TECHNICAL MEMORANDUM #5a

Pendleton IAMPs: Exit 207 & Exit 210

Concepts Evaluation and Screening

Date: April 27, 2020 Project #: 24043

Table 9 – Concept 2

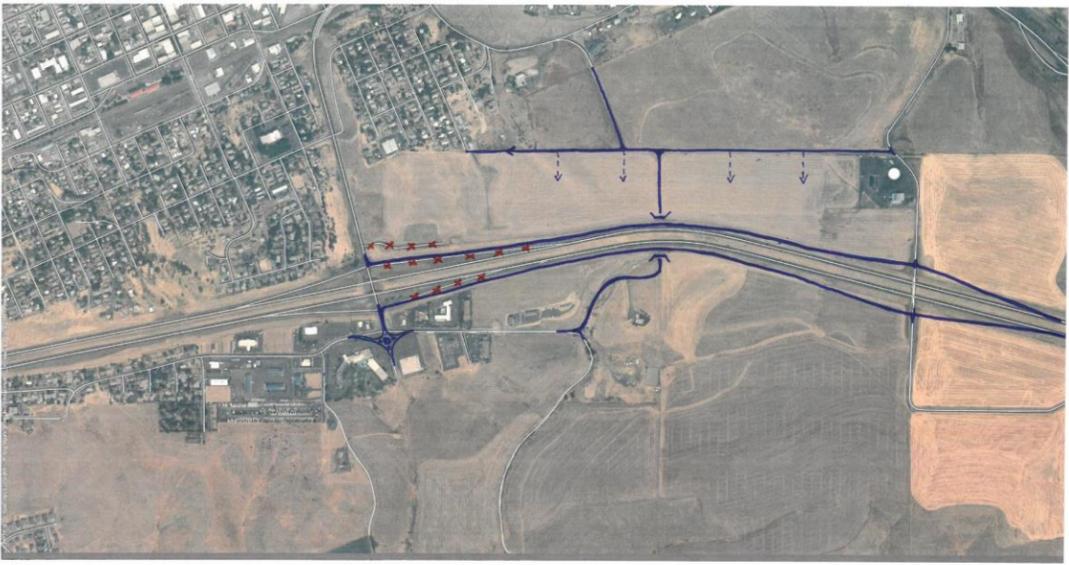
Exit 210 – Concept 2		Evaluation Information			Evaluation Results		
Concept Description and Illustration		Category	Evaluation Criteria	Scoring Key	Score	Comments	
<p>This concept converts the existing interchange to a split diamond interchange in which the westbound off-ramp and the eastbound on-ramp would be further to the east (where Goad Road is). This would allow development and existing neighborhoods north of I-84 to take access from a new road connecting to the new on/off ramps. It closes off Kirk Avenue, eliminating the close spacing from the westbound ramp terminal. It also relocates Nye Avenue further away from the eastbound ramp terminal and uses a roundabout to improve circulation. These adjustments improve access spacing thereby reducing potential conflicts and improving the capacity of the roadways.</p>  <p>EXIT 210 CONCEPT #2</p> 	Transportation	Addresses the limited intersection spacing between the WB ramp terminal and Kirk Avenue.	+1	Moves in the direction of ODOT's access spacing guidelines	+1	This concept closes off Kirk Avenue, eliminating the close spacing from the WB ramp terminal.

-1	Does not move in the direction of ODOT's access spacing guidelines		
			Addresses the limited intersection spacing between the WB ramp terminal and Kirk Avenue.	+1	Moves in the direction of ODOT's access spacing guidelines	+1	This concept relocates Nye Avenue further away from the EB ramp terminal and utilizes a roundabout intersection form to improve circulation efficiency
				-1	Does not move in the direction of ODOT's access spacing guidelines		
	Land Use/ Economic Development	Accommodates future growth and minimizes right-of-way impacts	+1	Alternative provides for long-term growth in the study area with minimal ROW impacts			
			-1	Alternative precludes long-term growth or has significant ROW impacts	-1	There would be ROW impacts associated with a new interchange at Goad Road. All of this infrastructure would be located outside of the Pendleton UGB. The new circulation network serving the northeast quadrant would require ROW, but most of these impacts would affect currently undeveloped property.

Accessibility	Moves in the direction of ODOT access spacing requirements	+1	Provides direct and efficient access to properties in the northeast quadrant of the interchange.	+1	The new split diamond interchange at Goad Road would provide direct access to the northeast quadrant of the interchange.	
			-1	Provides indirect or inefficient access to properties in the northeast quadrant of the interchange.			
	Cost	Cost relative to other concepts	+1	Low construction costs			
			0	Moderate construction costs			
		-1	Substantial construction costs	-1	A new interchange at Goad Road and the associated frontage roads would have substantial construction costs.		
Implementation	Constructability	+1	Project can be constructed with relative ease and/or can maintain existing traffic during construction.				
		-1	Construction of improvements will be a physical challenge and/or will require major detours during construction.	-1	While the majority of the split diamond interchange could be constructed while maintaining existing traffic, the scale of the project is comparatively large with many unknown complexities.

0		
On-line Public Feedback & Miscellaneous Evaluation Comments							
Similar comments as to #1.							
FHWA not likely to approve due to proximity of Exit 211.							
Next Steps							
Do not move forward for further evaluation.							
Justification							
Interchange spacing and length of frontage roads are not likely to be approved by FHWA
